SERVICE BULLETIN

PAPER MACHINERY CORPORATION

110331
TRANSFER TURRET
No. 229.1

(NEW) LOWER TRANSFER TURRET FOLLOWER PLATE (REF. #507-505)
PMC-1002

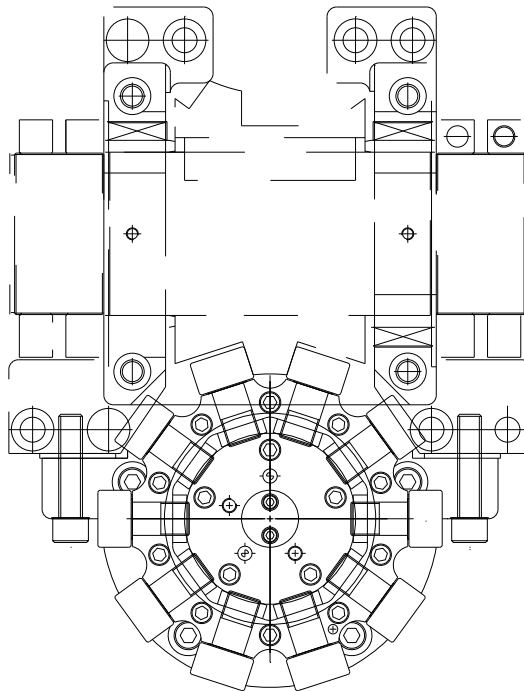
Paper Machinery Corporation has developed a new accurate method for replacing and re-pinning the Lower Transfer Turret Follower Plate. This method can be done in the field.

This assembly incorporates larger ($\frac{7}{8}$ ") studs on the Cam Follower which significantly reduces the risk of breakage.

This fully assembled plate can be ordered through PMC customer's service department using part #824-941.
